CITY OF
ISSAQUAH

CITY OF ISSAQUAH URBAN VILLAGE DEVELOPMENT COMMISSION AGENDA

The applicant is requesting preliminary plat approval for Parcels 1 and A. This property is split between two different Development Agreements: Parcel A is in the Issaquah Highlands Project using its Development Agreement adopted in 2011. Normally each portion of the property would be reviewed against its own Development Agreement. However, both properties are owned by the same builder who plans on developing them as a single, unified project. Furthermore, the WSDOT TDR Development Agreement was generally conceived as an extension of the Issaquah Highlands Project. As requested by the applicant and confirmed by Action Memo #111811, with a few exceptions these Parcels will both be reviewed using the Issaquah Highlands Development Agreement. See **Attachment E** for the Action Memo.

Pedestrian routes through the plat

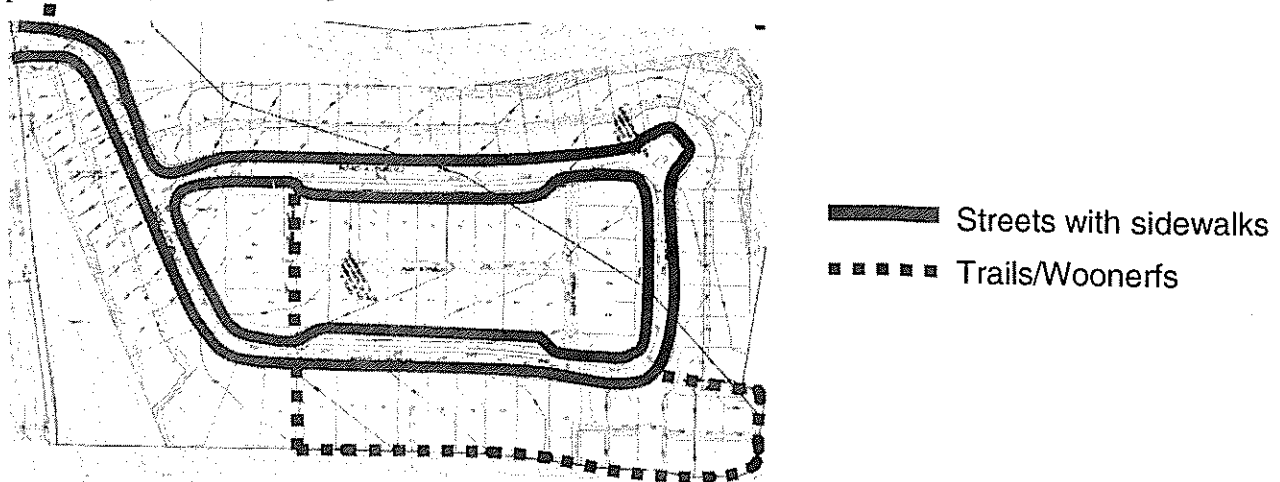
Interconnectivity is a critical component to neighborhood character and fostering a circulation system that encourages walking and bicycling. The primary pedestrian circulation system at Issaquah Highlands coincides with the street system, since sidewalks are a required element of all streets, just as the streets in this plat do. The applicant has proposed an unique sidewalk system as shown on Sht. P04. Sidewalks on the outside of Road A have the traditional placement; however, sidewalks on the inside of Road A, are placed close to the Road at the corners of the block but veer into the adjacent tracts (Tracts E and G) to provide access to the lots. The applicant has proposed Tracts E, F, and G to provide consistency of landscape design and maintenance along the street front. These tracts will also provide an opportunity for unique passive and active uses to be distributed throughout the neighborhood. These might include nodes, sitting areas, small play opportunities, and other elements consistent with the Neighborhood Type. In a pedestrian friendly community, sidewalks are direct and convenient, which means they are not typically meandering. However, in this case, the sidewalks will provide convenient access and consolidate the open areas for the various activities in the tracts. The applicant has described these but has not yet provided detailed designs. The sidewalk in Tract F and in Tract G adjacent to Lots 55-58 does not veer into the tract, which will result in the need to provide individual walks from the sidewalk to the lots, carving up Tract F and G. Instead, the walks should be placed in close proximity to the lots. [Condition 35]

In addition, there is another pedestrian system, trails. There are four trail types in this plat, all of which are discussed below under the Section on **Trails**, except the woonerfs portion discussed here. Also to ensure that there is perpetual access to these trail routes, an easement shall be provided. [Condition 55]

Locations where paving will change in association with pedestrian route crossings

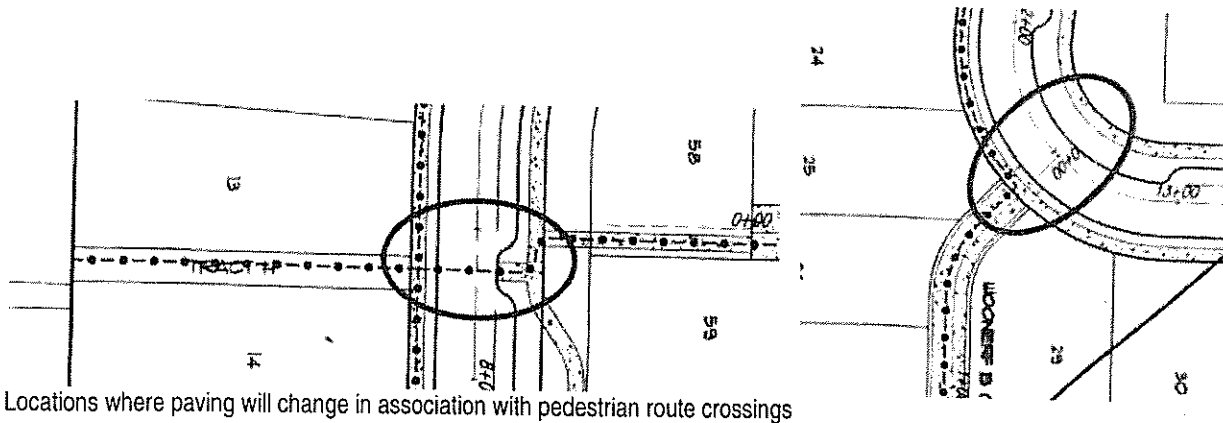
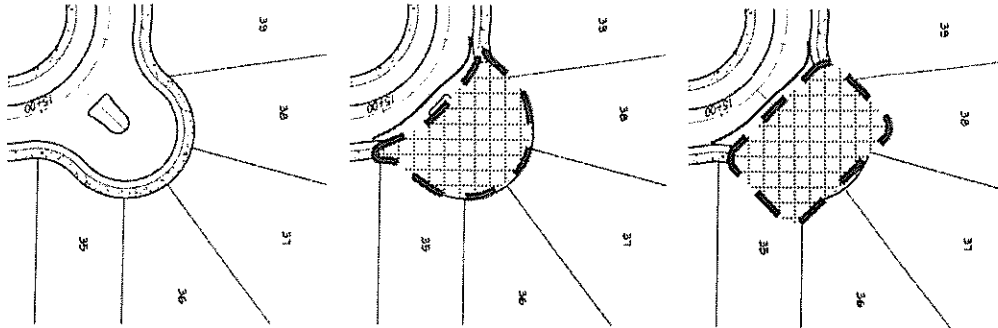
To improve the pedestrian orientation, where pedestrian ways intersect with vehicular routes, including streets and alleys, treatments shall be used which clearly delineate the pedestrian priority and enhance pedestrian safety. This is consistent with the objective: *"Encourage pedestrian priority in circulation by creating paving changes, raised crosswalks, and neighborhood street entry bottlenecks to slow vehicle traffic"* as well as *"Paving patterns changes, varied paving materials and color, and accent paving are used to reinforce the residential character of the neighborhood at high use and important pedestrian locations."* [Condition 43]

Left: original proposal.:

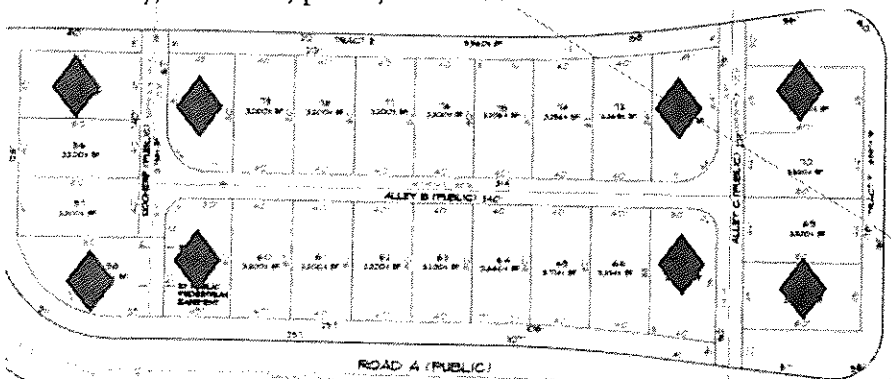
The other location that needs further pedestrian circulation refinement is the sidewalk at Lots 35 through 38. To provide vehicular access to the lots, a road bulb-out is shown. This improves vehicular access while making the pedestrian route significantly longer and less direct. As pedestrians are given priority, the design must facilitate pedestrian movements over vehicular, while accommodating automobile as well as EF&R access. Also EF&R must be able to get within 150 ft of the farthest point of a house on any of these lots (as the hose lays). A solution would be to continue the curb line as if the street turned there, and using a driveway cut, create a shared surface, such as a woonerf, behind the curb. This will be a low vehicular volume area which will be appropriate for a pedestrian-oriented, shared-surface solution such as a woonerf. [Condition 44]

Middle and Right: possible pedestrian oriented solutions.

Location of wider corner lots

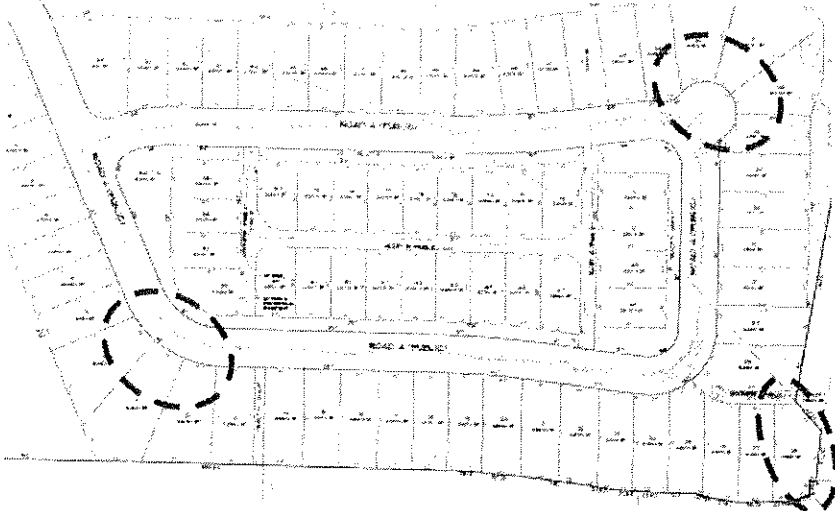
Conversely, some lots are narrower than the typical lot in the plat, such as at the corners of Road A. The Development Agreement places importance on creating a pedestrian friendly and socially gregarious public realm in which houses address the street and auto dominance is reduced. The design of these narrow lots (Lots 10-12, 28, 36-38) increases the frequency of curb cuts and potentially diminishes the relationship between the house and the street. Two actions are necessary: limit the width of the curb cut and at Building Permit, carefully review the placement of the house to ensure it has a strong relationship with the street as well as the other homes, "...where the whole composition of streets, trees, parkways, walks, front yards and front porches define and contain a common space for residents to stroll, meet, play, and socialize." [Condition 45]

Location of begin/end of potential trail connection in Block 24

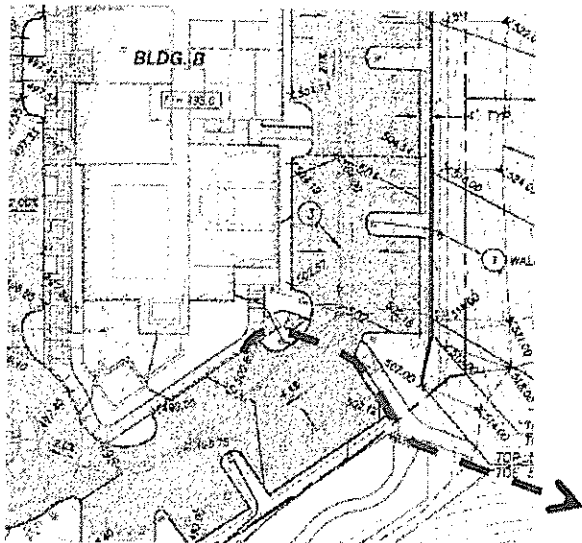
Block 24, Lot 2's design, provided a stub to a trail, anticipating a trail leading up to Parcels A/1, such as Tract I. The applicant is proposing to build a woonerf that will be the receiving point for the Block 24 trail, but not to build the trail connection. Another entity will construct it in the future.
